7/22/92	ADDENDUM 1 - GENERAL REVISION
DATE	REVISION
STATE OF HAWAII DEPARTMENT OF TRANSPORTATION HIGHWAYS DIVISION	
SITE PLAN	
HAIKU O&M FACILITY	
INTERSTATE ROUTE H-3	
F.A.I. PROJ. NO. I-H3-1 (66)	
SCALE: 1" = 20'	DATE: JUN 1992
SHEET NO. PBI OF 28 SHEETS

HAIKU O & M FACILITY
INTERSTATE ROUTE H-3
F.A.I. PROJ. NO. I-H3-1 (66)

7/21/92	ADDENDUM I - DELETED KEYED NOTE 28
DATE	REVISION

1/22/92	APPENDUM 1 - REVISED ROOF OPENINGS FOR EXHAUST FANS AND DUCTS
DATE	REVISION
STATE OF HAWAII DEPARTMENT OF TRANSPORTATION HIGHWAYS DIVISION ARCHITECTURAL ROOF PLAN - 1B HAIKU O & M FACILITY INTERSTATE ROUTE H-3 F.A.I. PROJ. NO. I-H3-1 (66)	
SCALE: 1/8" = 1'-0"	DATE: JUN 1992
SHEET NO. PB5 OF 28 SHEETS

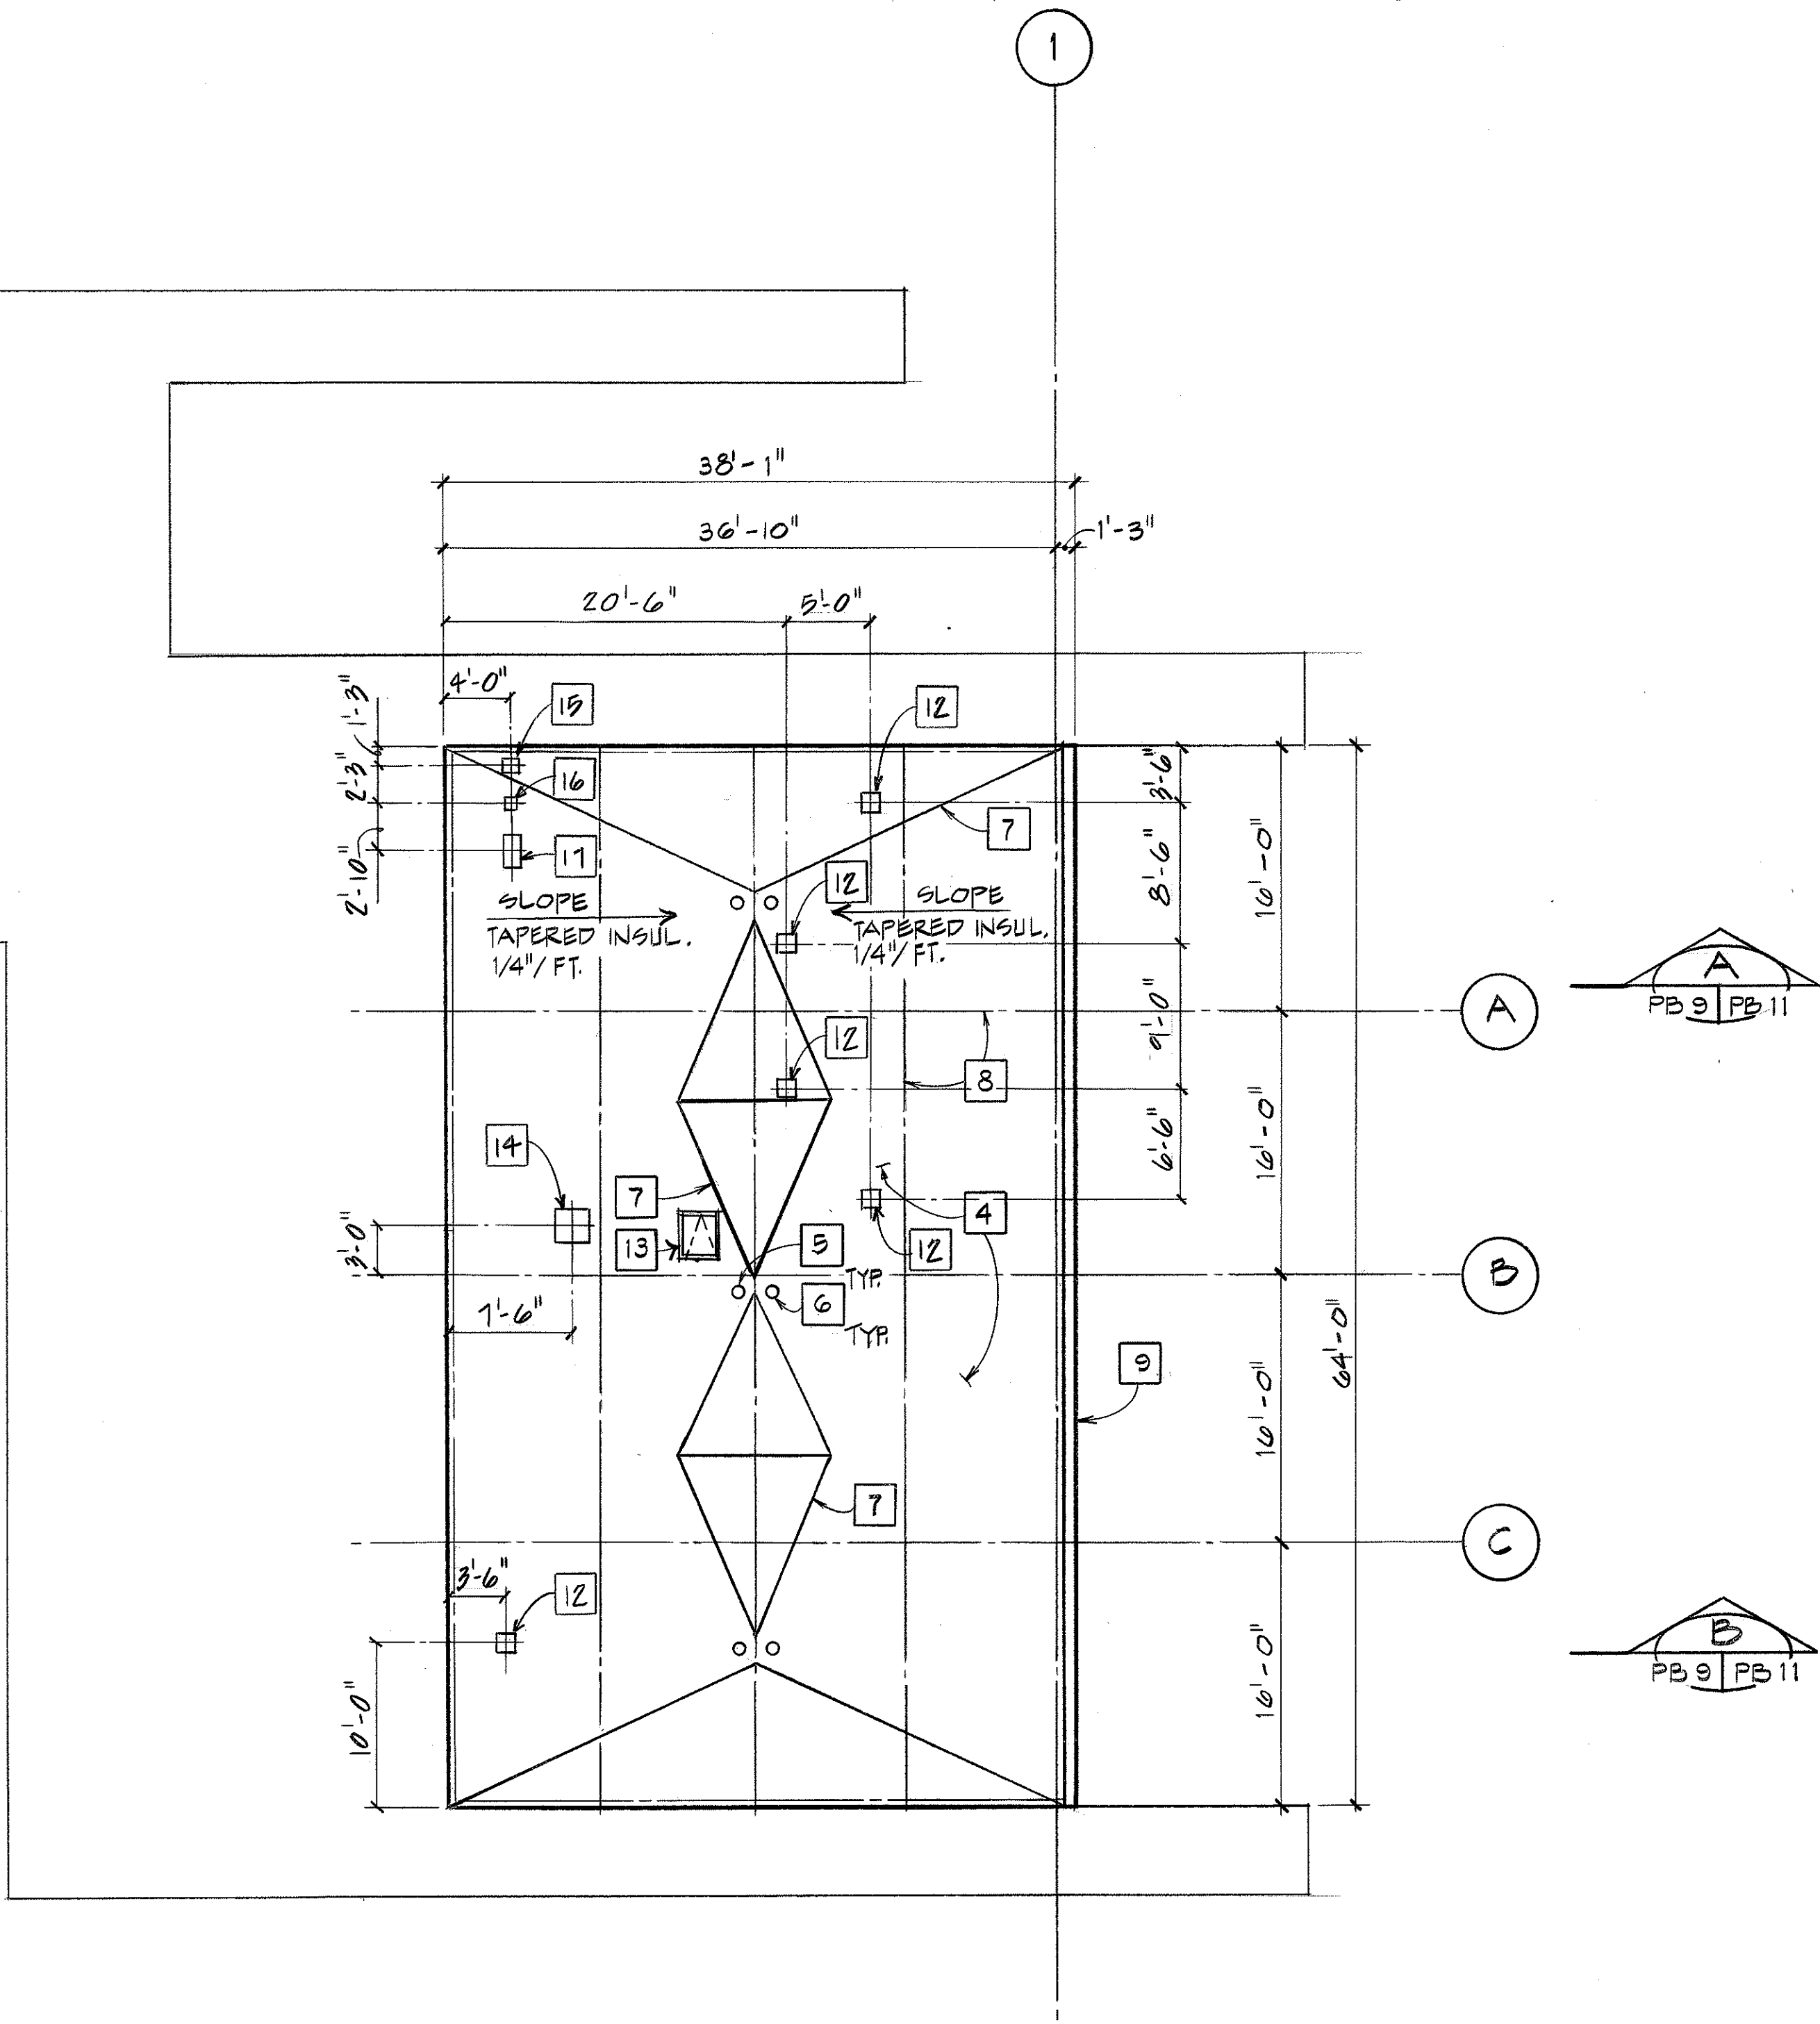
DATE	REVISION
7/22/92	ADDENDUM 1 - ADDED ROOF OPN'GS FOR EXHAUST FANS AND DUCTS
STATE OF HAWAII DEPARTMENT OF TRANSPORTATION HIGHWAYS DIVISION ARCHITECTURAL ROOF PLAN - 0B HAIKU O & M FACILITY INTERSTATE ROUTE H-3 F.A.I. PROJ. NO. I-H3-1 (66) SCALE: 1/8" = 1'-0" DATE: JUN 1992 SHEET NO. PB9 OF 28 SHEETS

TOILET ROOM PLAN

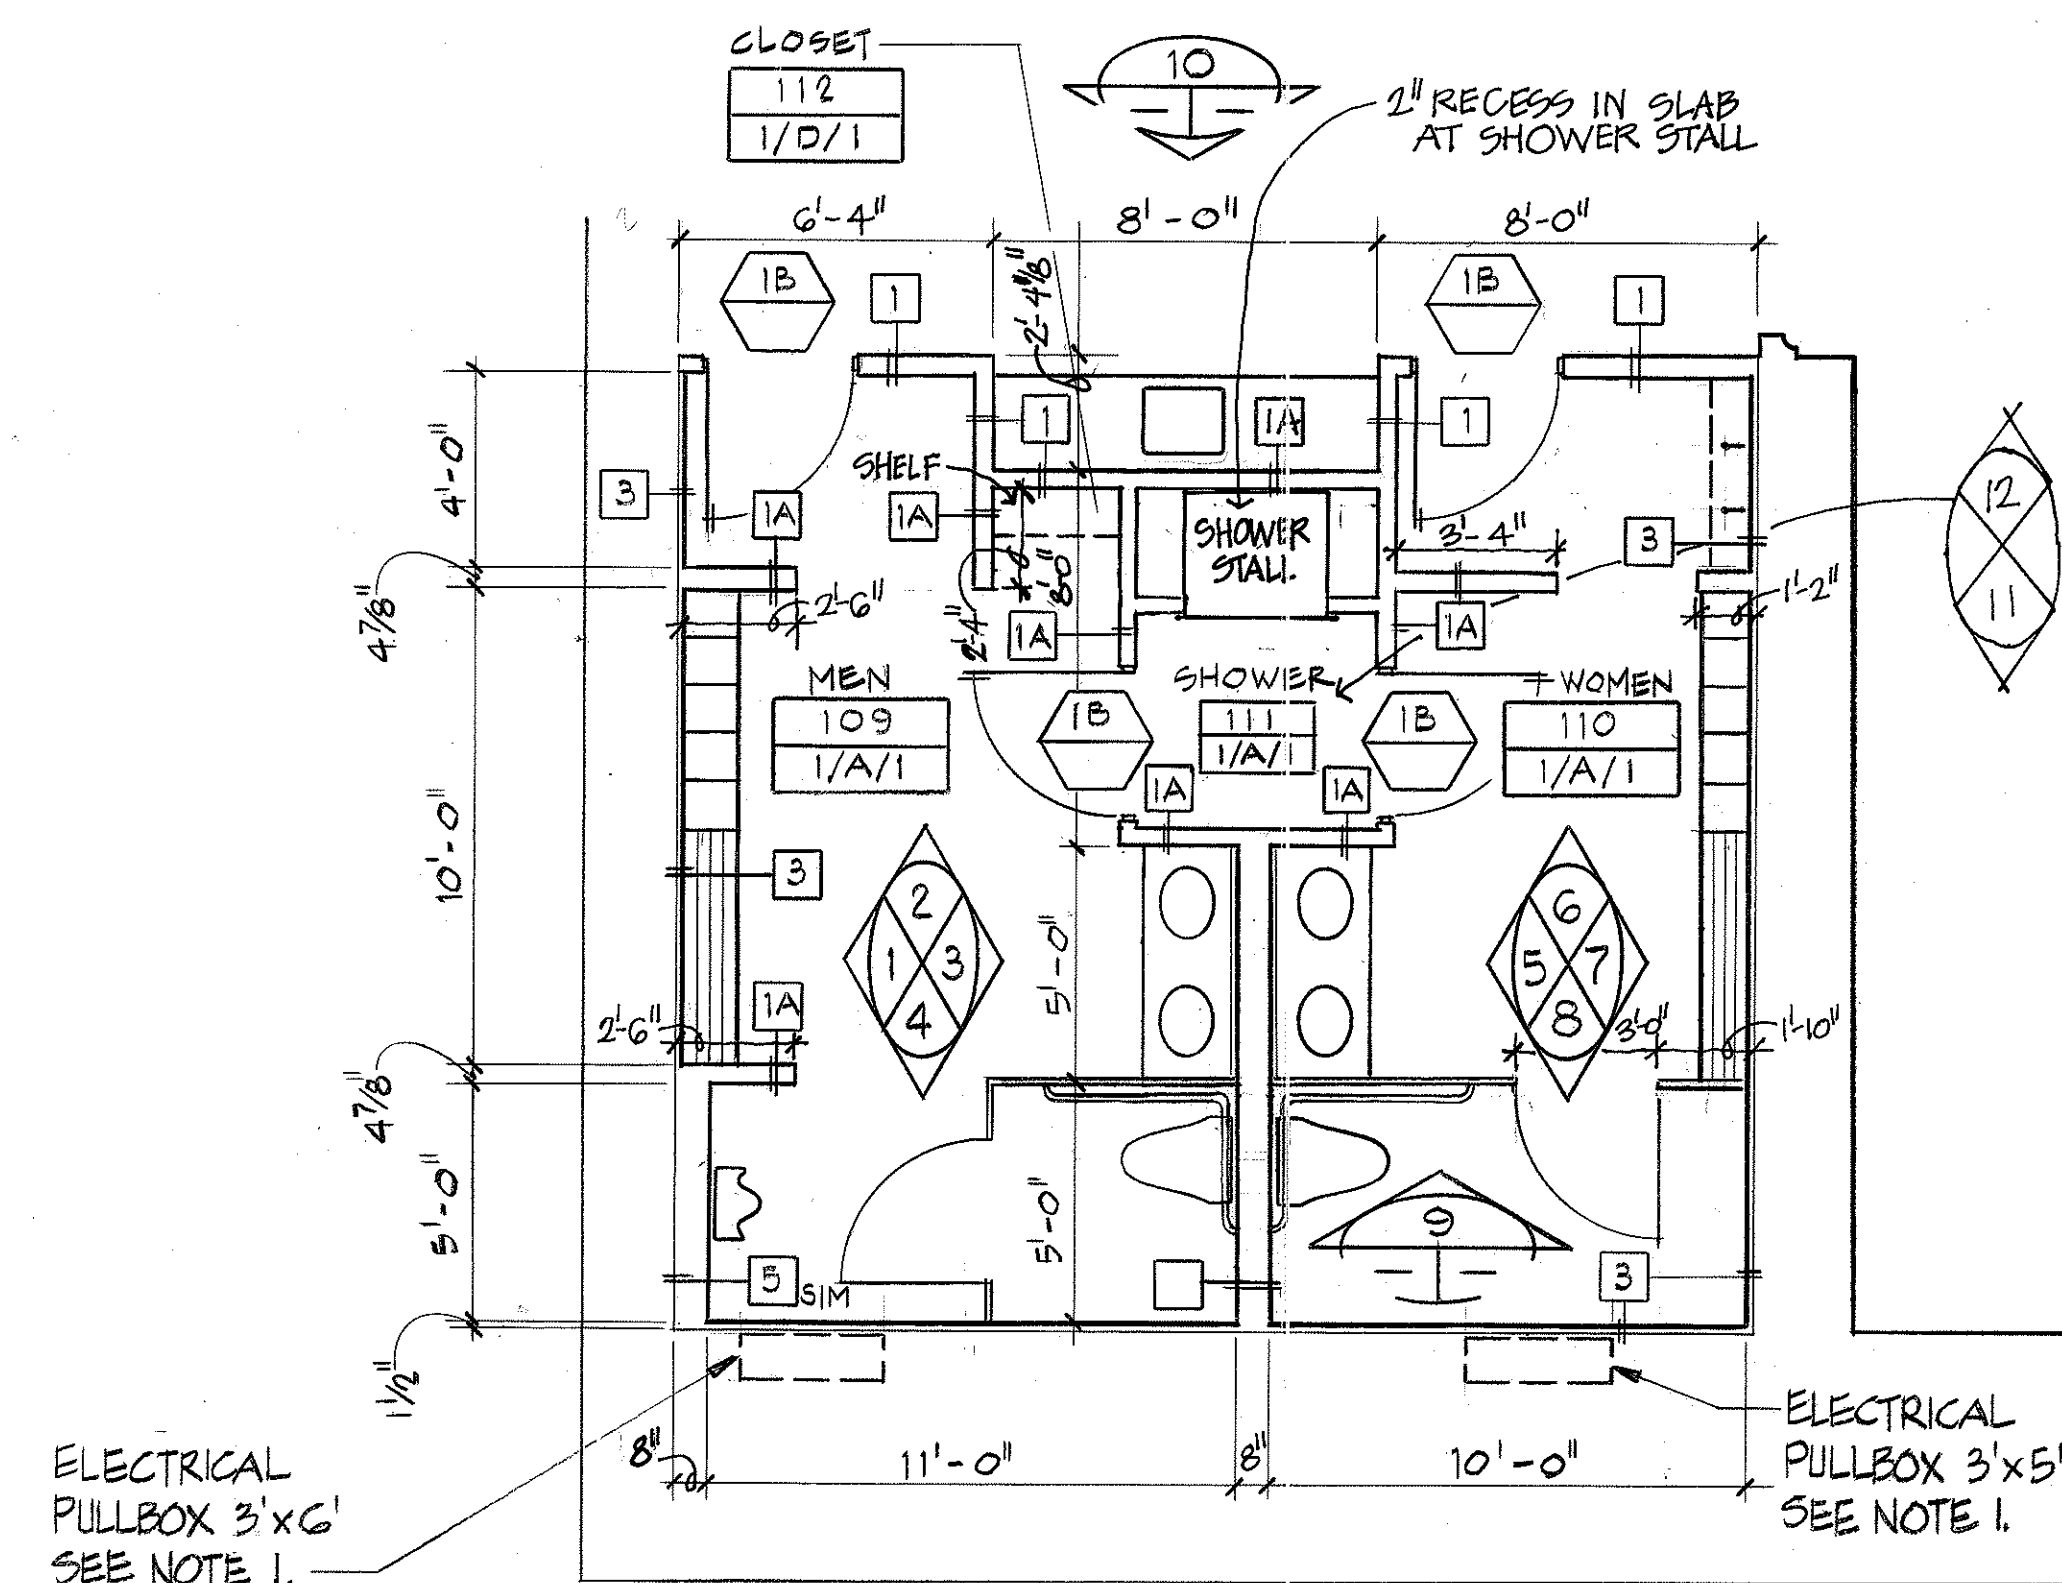
7/22/92	ADDENDUM I - ADDED NOTE I AND LOCATION OF PULLBOXES
DATE	REVISION

1. AT EXISTING ELECTRICAL PULLBOXES, REMOVE METAL DOOR, ENLARGE OPENING AND INSTALL NEW HOLLOW METAL DOOR, FLUSH WITH TILE FINISH.
